WALDEN PRESERVE 2

Filing No. 4

Grading & Erosion Control Plans

PCD FILE NO. SF-18-034

TYPICAL RIPRAP APRON/CULVERT OUTLET PAVING (C)
 NOT TO SCALE

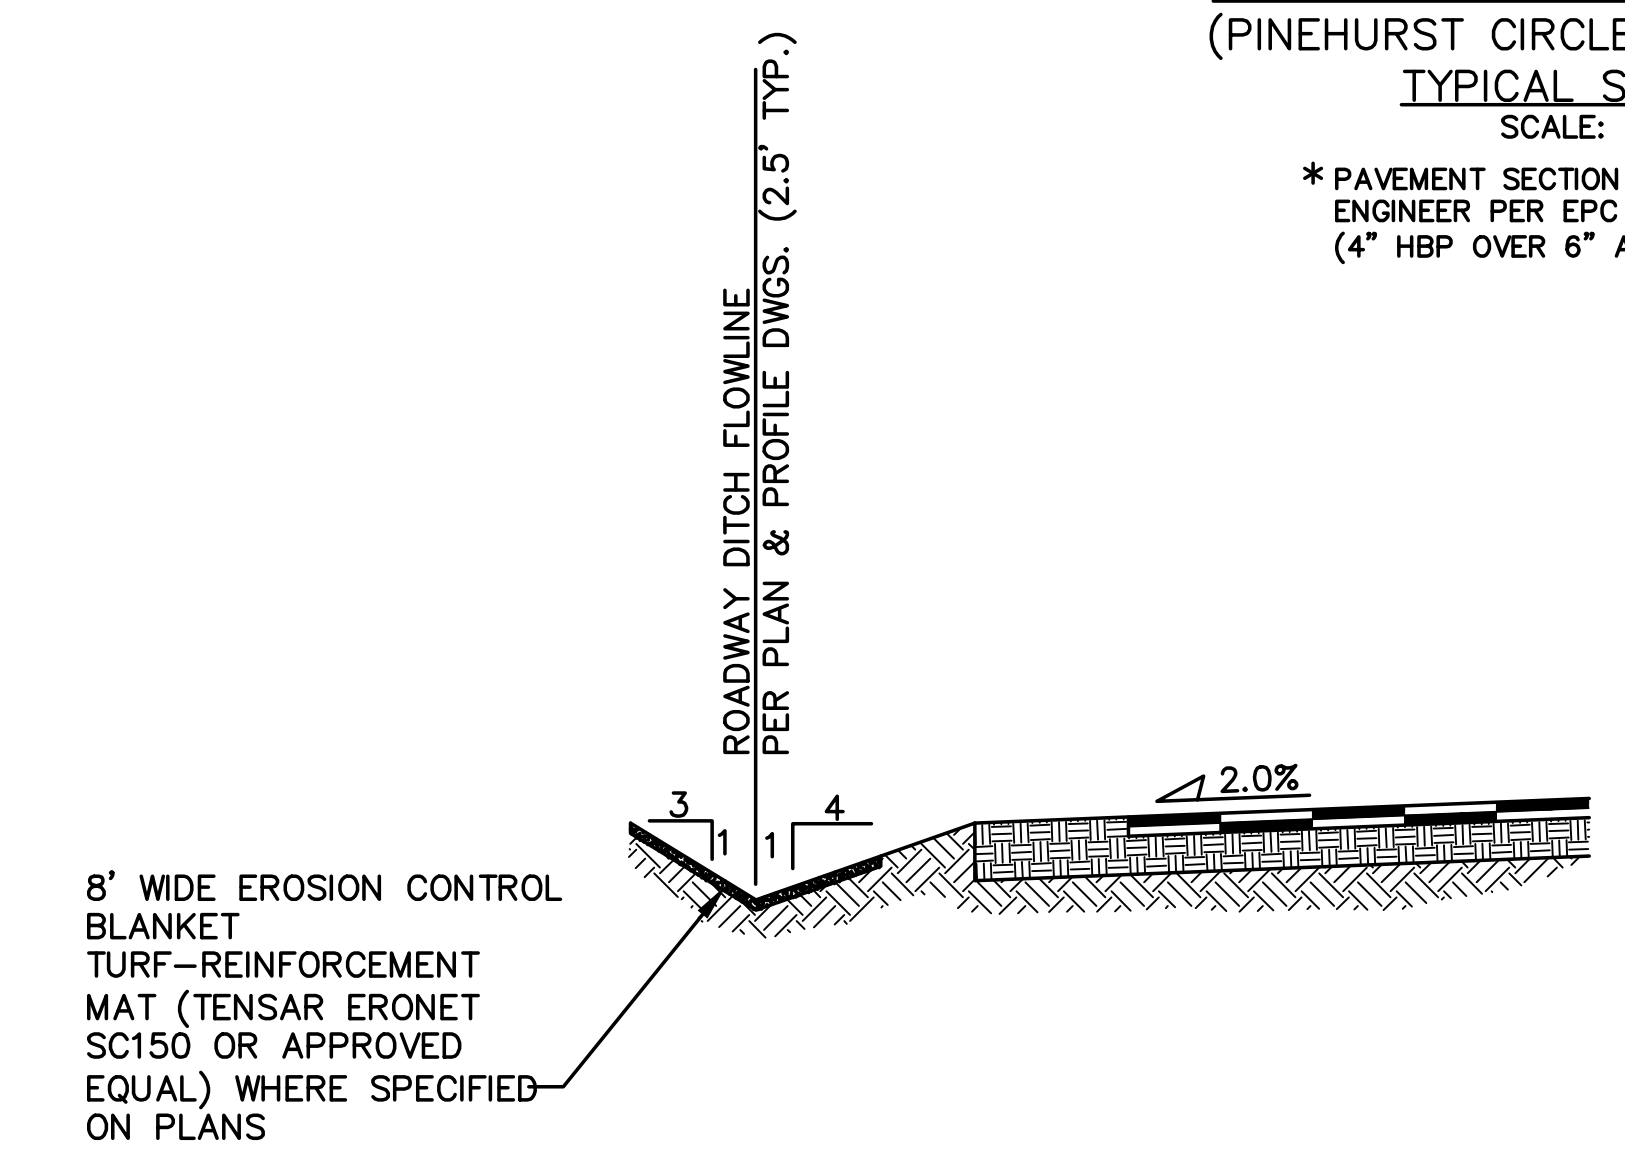
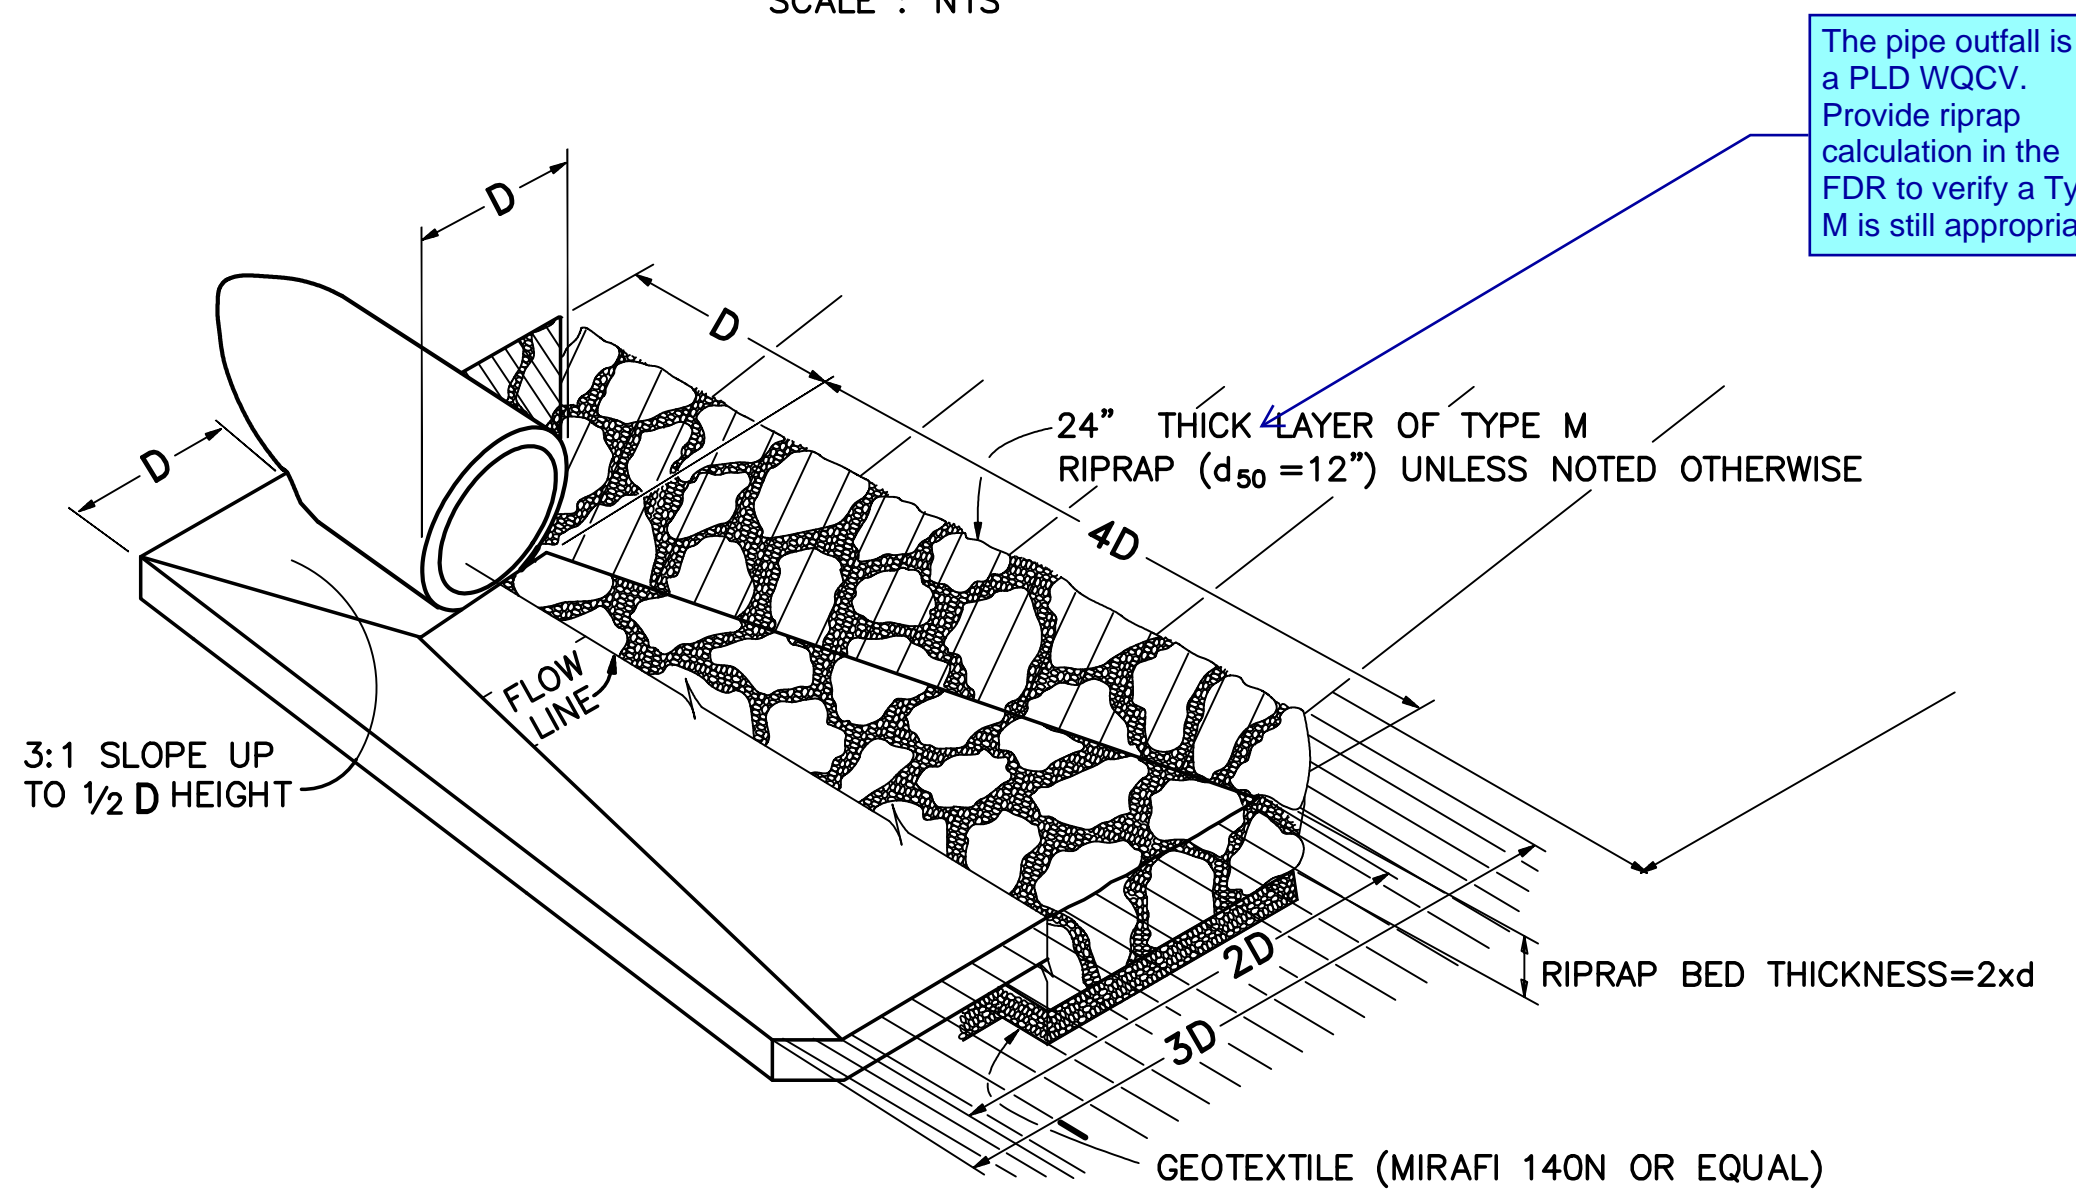
The pipe outfall is for a PLD WQCV. Provide riprap calculation in the FDR to verify a Type M is still appropriate.
